RAMBOLL RESPONSE TO FALMOUTH HARBOUR AUTHORITY

Project name **Falmouth Docks Redevelopment**
 Project no. **RUK2023N00104**
 Client **A&P**
 Memo no. **04**
 Version **0.1**
 Date **12/10/2025**
 Prepared by [REDACTED]

Case reference MLA/2025/00157

Figure 1 – Predicted change in annual deposition of fine sediment after development

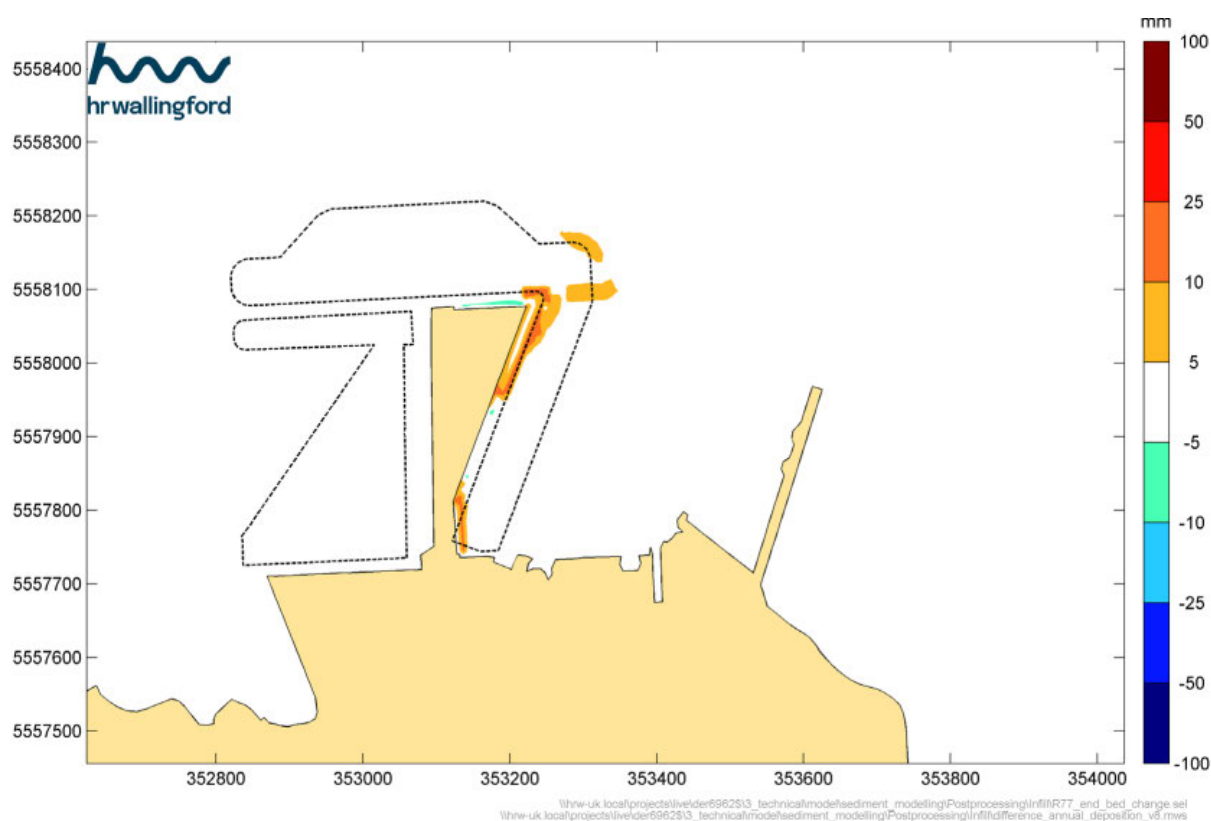
- *'Maintenance dredge volumes are significantly lower than the capital dredge volumes stated as 643,000 cubic metres (m3) predicted to be around 8000m3 every five years. No modelling has been conducted on plumes associated with maintenance dredging. Clarification is required to confirm if a backhoe dredger could be used to remove material or would this activity need different methodology?*

Maintenance dredge volumes will be significantly lower than the capital dredge volumes. Within the dredged areas directly associated with the proposed development the volumes of infill are predicted to be 1,600 m³/year. This small quantity suggests maintenance dredging every year is unlikely to be required. A suitable approach to maintenance dredging would be to dredge up to approximately 8,000 m³ every 5 years (or depending on operational requirements, up to approximately 16,000 m³ every 10 years), as required, mostly within the eastern berth pocket (Western Wharf), which is where predicted changes in annual deposition are modelled to occur (see Figure 1 – extract from Technical Appendix 6.2 Sediment Transport Modelling Figure 3.14).

It is proposed that the limited maintenance dredging would be undertaken using a backhoe dredger, and on an adjusted flood tide (amended to 1.75 hours before low water to 1.75 hours before high water), in line with the methods employed for the proposed capital dredge. This would minimise fine sediment deposition in the area and avoid impacts to sensitive habitats in the area.

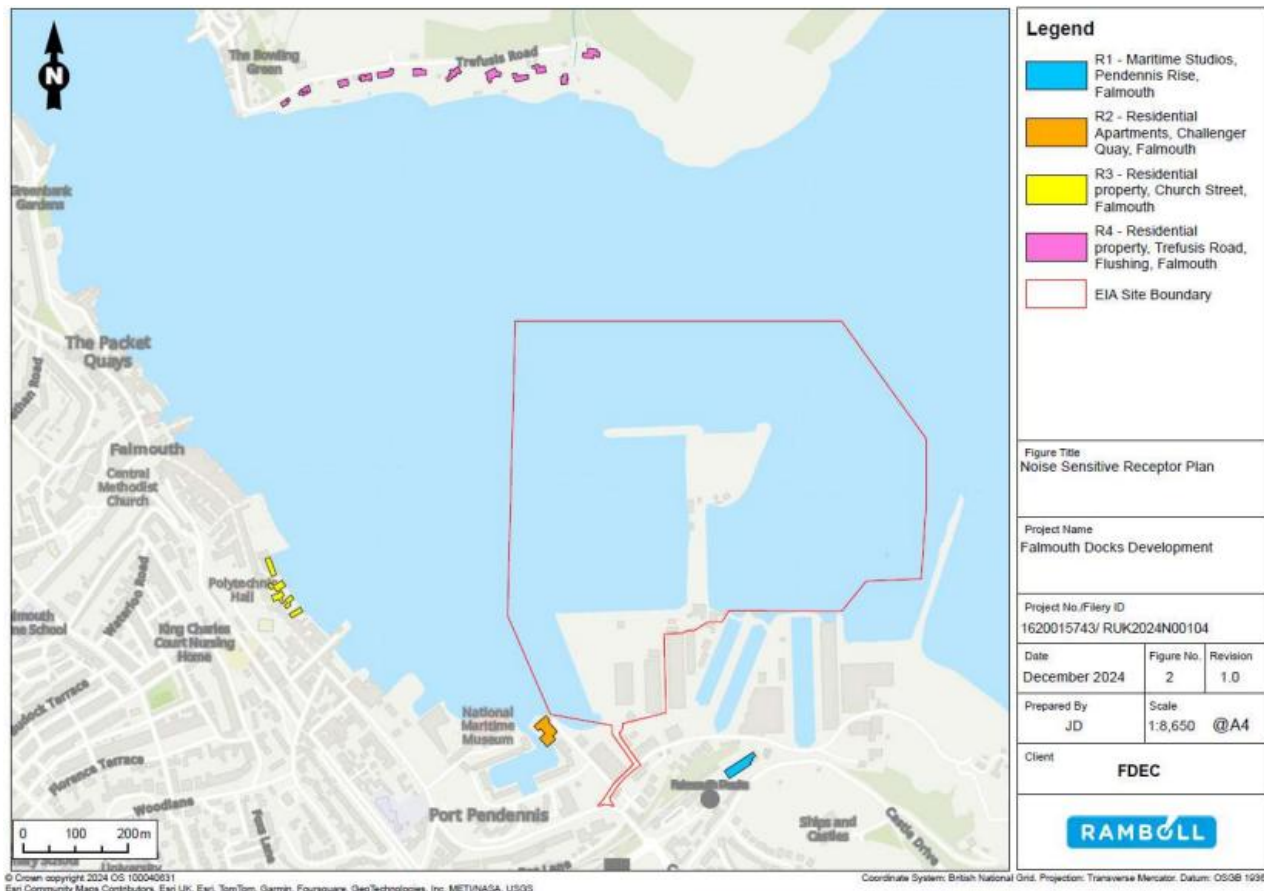
- *Additional information is required on the expected increased noise levels that will be experienced at the marina and on any planned noise abatement in particular, if any works are carried out after hours or at particularly busy summer season'.*

Noise sensitive receptors selected for the noise assessment (ES Chapter 14) are shown in Figure 2.

Other potential receptors were initially considered as part of the noise assessments. However, it was found that the following receptors are appropriate based on:

- Receptor R1 (Residential Receptors to the South of the Dock known as Maritime Studios, Pendennis Rise Falmouth) represent the worst-case scenario for receptors on Pendennis Rise, Falmouth due to its prominent location to the south of the site.
- Receptor R2 (Residential Apartments, Challenge Quay, Falmouth, TR11 3YL) represent the worst-case scenario for receptors around Bar Road and Falmouth waterfront. It is considered worst case based on its proximity to the site and lack of screening.
- Receptor R3 (Residential properties along Church Street Falmouth) represent the worst-case scenario for receptors to the west of the site due to the façade facing across the Harbour and with little screening in between.
- Receptor R4 (Residential properties along Trefusis Road, Flushing, Falmouth) being the worst-case scenario receptor to the north of the site across the open water to Flushing.

Therefore the results of both the construction noise assessment and operational noise assessment are deemed applicable (and worst-case) for the marina and moorings in the inner harbour.
